## ORIGINATION FORM

### Proposed Revisions to a Standard Plans Index

Index Number: 676-010

Index Title: CABINET INSTALLATION DETAILS

GROUND MOUNTED CONTROLLER CABINET

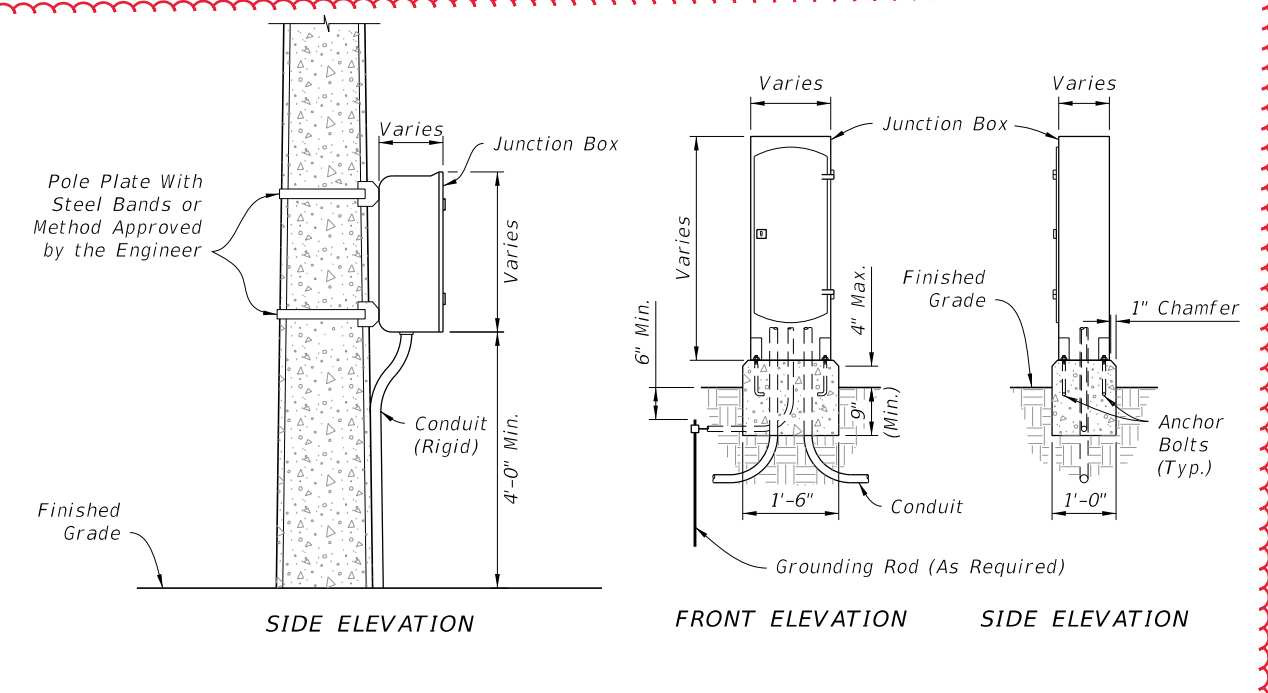
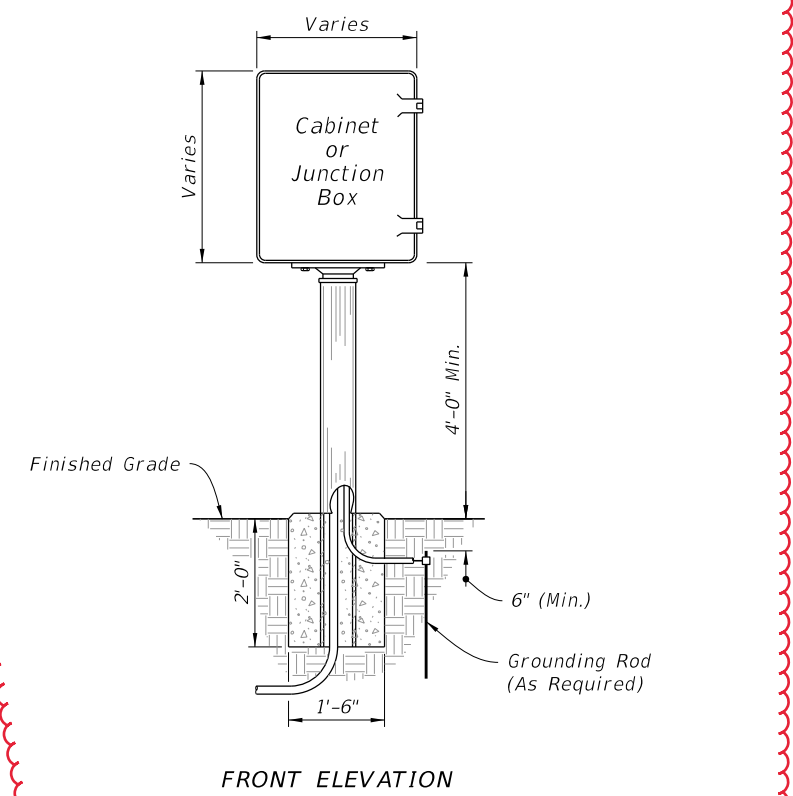
**UPDATE FOUNDATION AND ADDED MAINTENANCE SERVICE SLAB**

**UPDATE FOUNDATION AND ADDED MAINTENANCE SERVICE SLAB**

1. Service Slab: slope 1/4" to 1" for drainage. Not required in sidewalk, pavement areas, or where R/W is restricted.
2. The number, size and orientation of conduit sweep will vary according to site condition or locations. Provided two spare 2" PVC conduits in all bases. Place the exits of the spare conduits in the direction of the center rear of the cabinet base and into a pullbox. If obstructions prevent the spare conduit from exiting to the rear, or the rear of the cabinet is located on the R/W line, locate as directed by the Engineer. Cap all spare conduit sweeps with a weatherproof fitting.

INTERCONNECT JUNCTION BOX

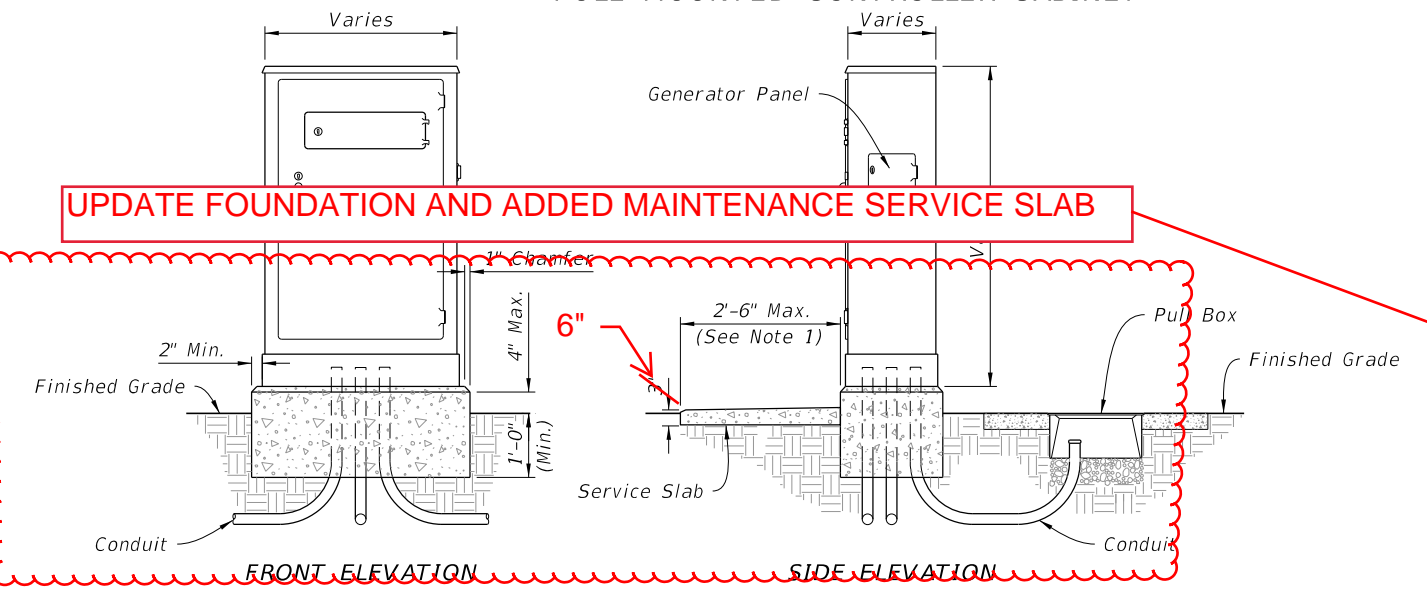
**MOVED TO SHEET 3**

## NEW SHEET 2

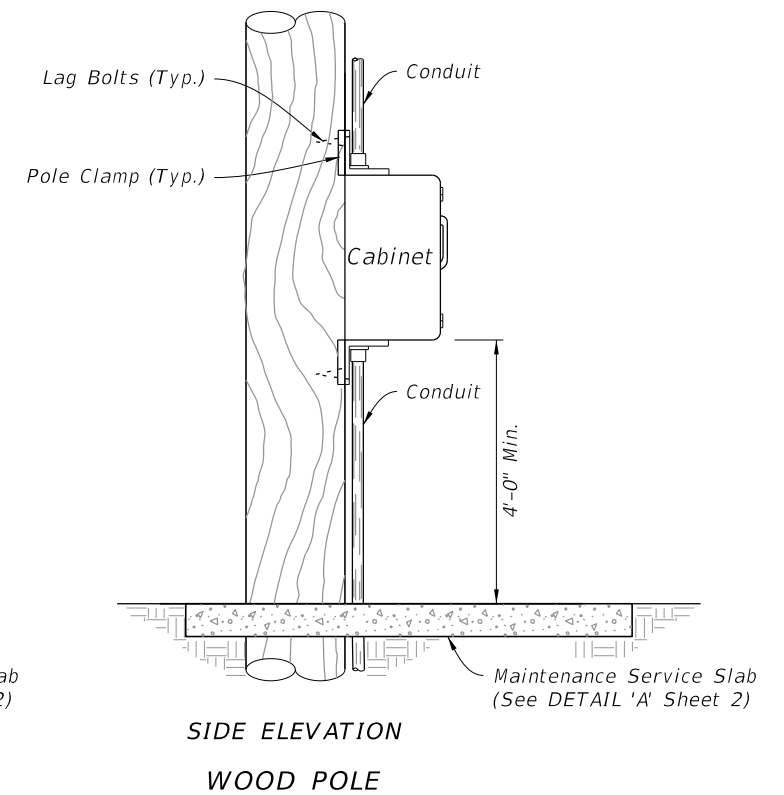
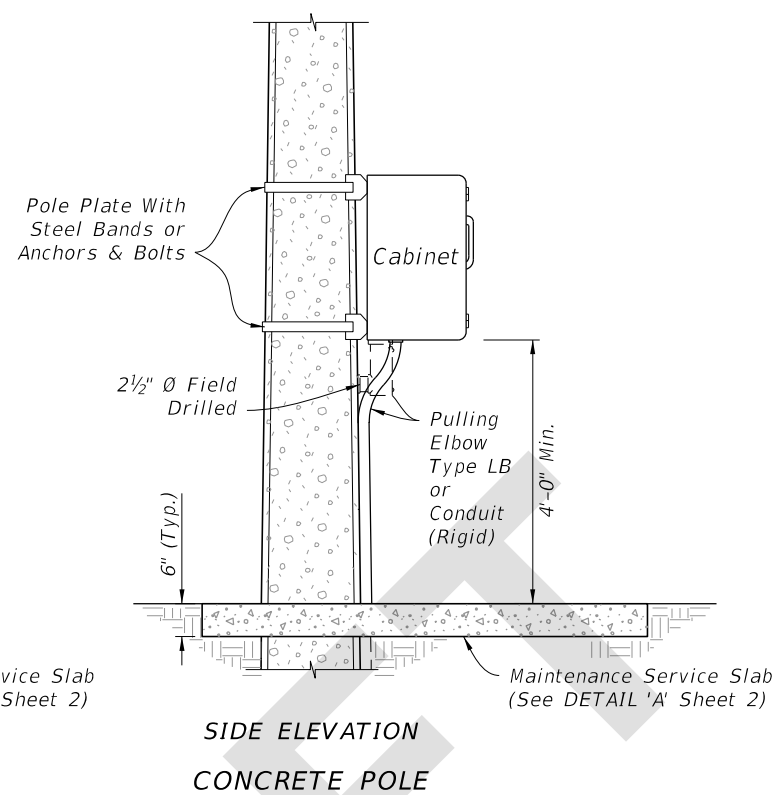
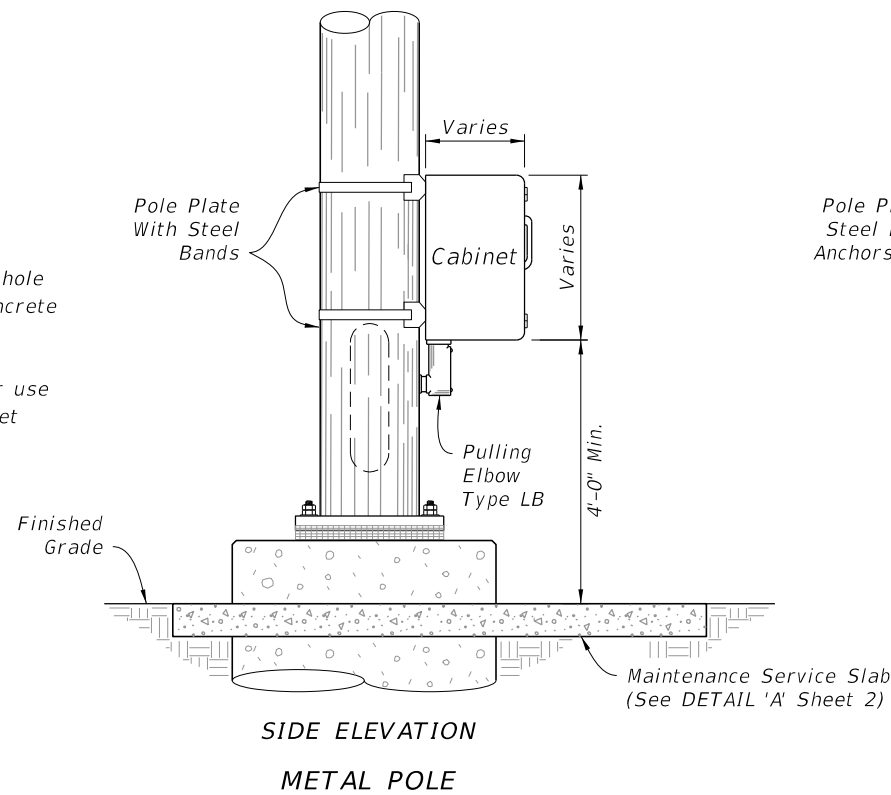
Sheet 2: New Sheet - details for Intelligent Transpiration System (ITS) cabinets and service slab requirements.

## NEW SHEET 3

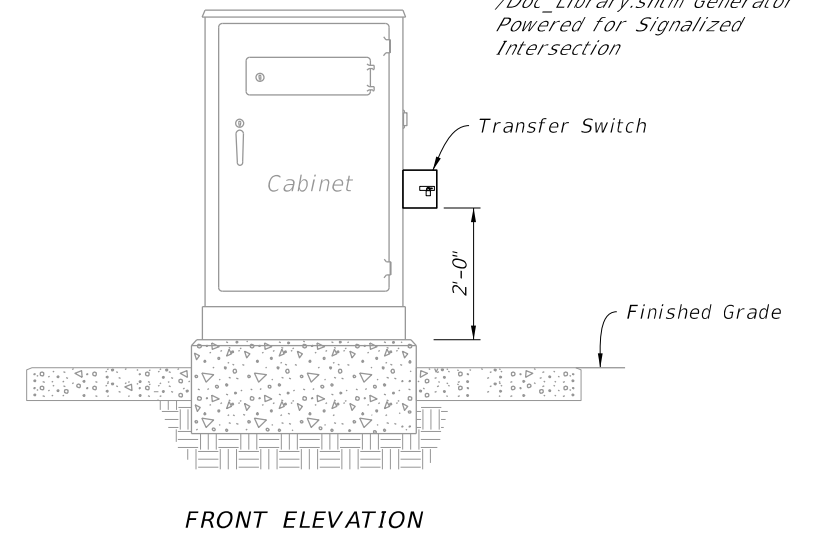
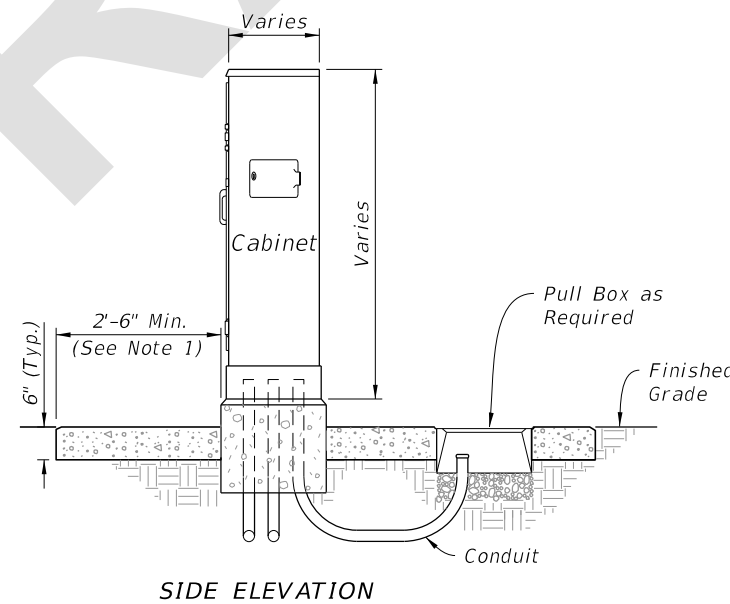
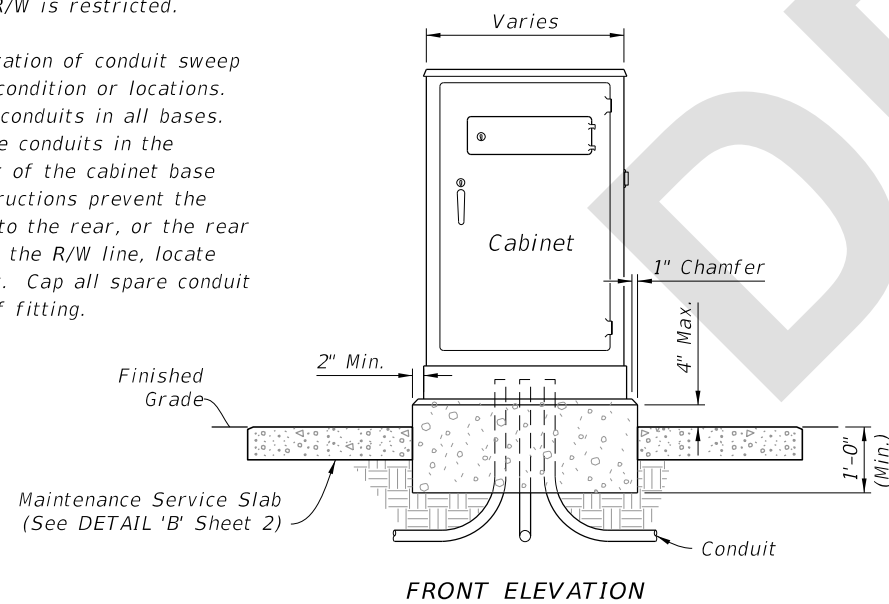
Sheet 3: New Sheet - INTERCONNECT JUNCTION BOX and PEDESTAL MOUNTED CABINET Details.
